Technical Service Bulletin

13 Rattling noises at idle speed

13 20 08 2060662/1 September 15, 2020.

Model(s)	Year	VIN Range	Vehicle-Specific Equipment
Q5	2020	All	DL382E

Figure 2. Securing clip.

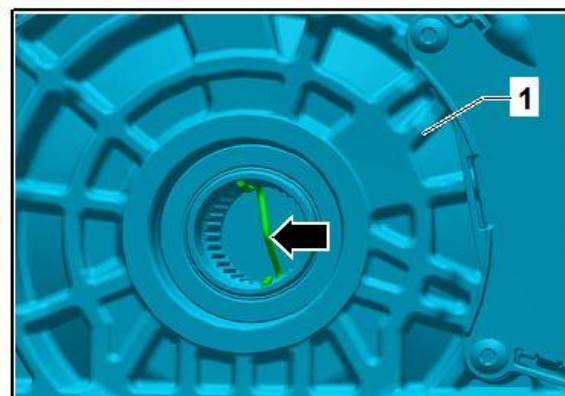
3. Replace the dual-mass flywheel with a dual-mass flywheel part number 06L105266C according to the repair manual, *Engine >> Servicing – 4-Cylinder 2.0L 4V TFSI Engine (EA 888 Generation III) >> 13 Crankshaft, Cylinder Block >> Cylinder Block, Transmission Side >> Dual Mass Flywheel, Removing and Installing*. The modification to index C optimizes the noise characteristics.
4. When installing the new dual-mass flywheel, note whether the securing clip part number 0DK 141 145 (Figure 2) in the drive splines of the electric drive motor has been fitted according to the repair manual. If it is missing or damaged then replace the securing clip.
